Date: July 13th, 2022
Project: Battery District – Site C
RCI No: 0466N2

Battery District DAP #2 Revisions Changes:

Narrative/Responses to DAP Panel Comments

Ground Level

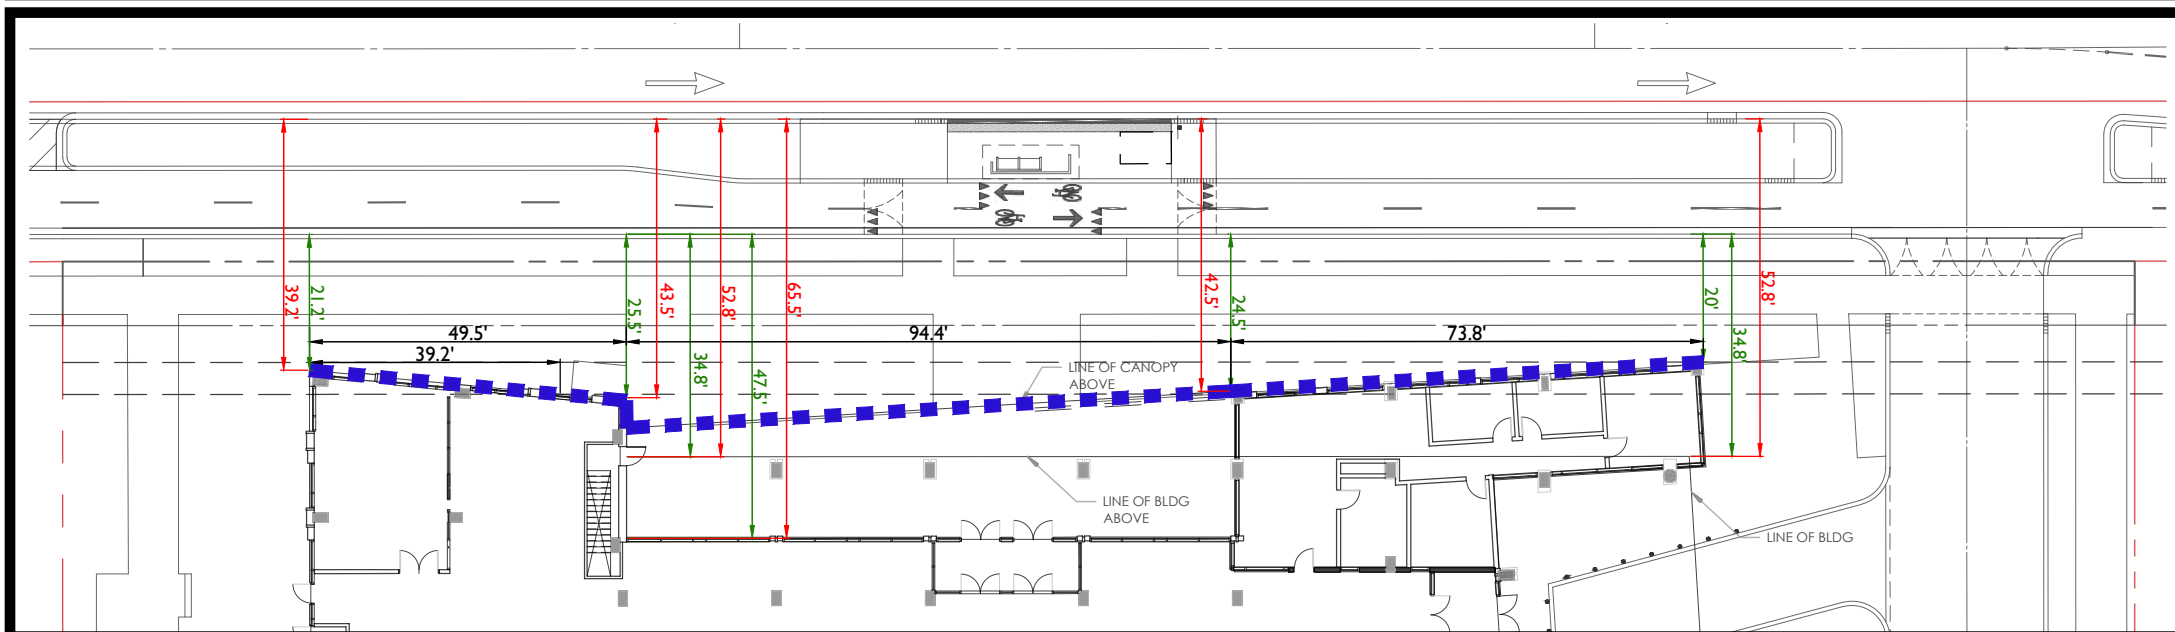
Comment #5: *Provide additional exhibits and information from a contextual basis regarding the setback along Battery Lane, the pedestrian experience along the building front façade elements, perhaps a street section and a diagram showing the fire code restrictions to setback.*

Response: Additional exhibits are provided to support the front building setback that varies in depth, height, and plane, to enrich the pedestrian experience along the front façade and to assist in understanding neighborhood context, including:

3. Dimensioned Plan showing Fire Code restrictions resulting from the installation of the median separated cycle track on the south side of Battery which pushed the travel lane of Battery Lane further from the building and which travel lane curb certain Fire Code access dimensions are calculated.

Minimum Offset from Curb 20' East - 21.2' West

52% of Front Facade is within the 20'-25' Bethesda Downtown Guideline for Neighborhood Connector Street

Westside Tower Base 21.2' - 25.5'

Front Porch 47.5'

Eastside Varena Base 20' - 24.5'

Weighted Average 33.5' setback from Cycle-Track curb

Weighted Average 51.5' setback from Roadway curb
